# SERVICE BULLETIN

TS-830S

#857

SUBJECT: TS-830S Transmitter "Talkback"

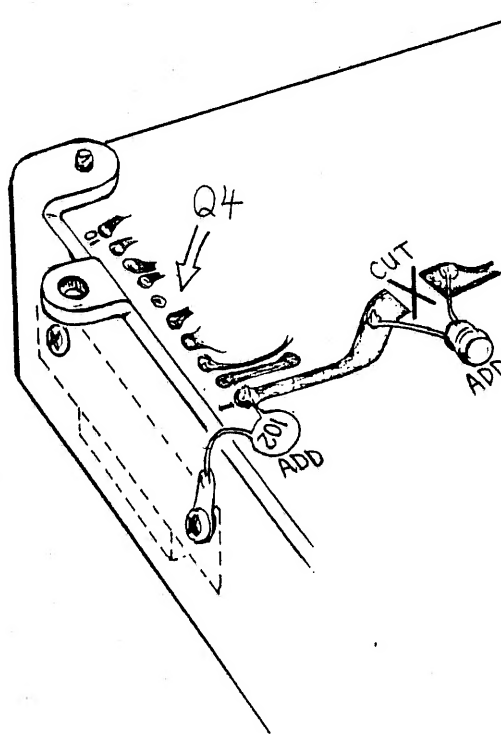
Transmitter "talkback", either with or without a linear amplifier, may be eliminated by adding a filter at the receiver audio power amplifier.

On the AF unit X49-1140-00 at Q4, cut the 12V DC B+ line between R47 and C28, and add a 1 $\mu$ h choke (L40-1092-02) in-line. Add a .01 $\mu$ F cap (C52-1710-36) from the IC pin 1 to ground, as shown using a 3mm lug (E23-0015-04) under the IC mounting screw on the Heat Sink.
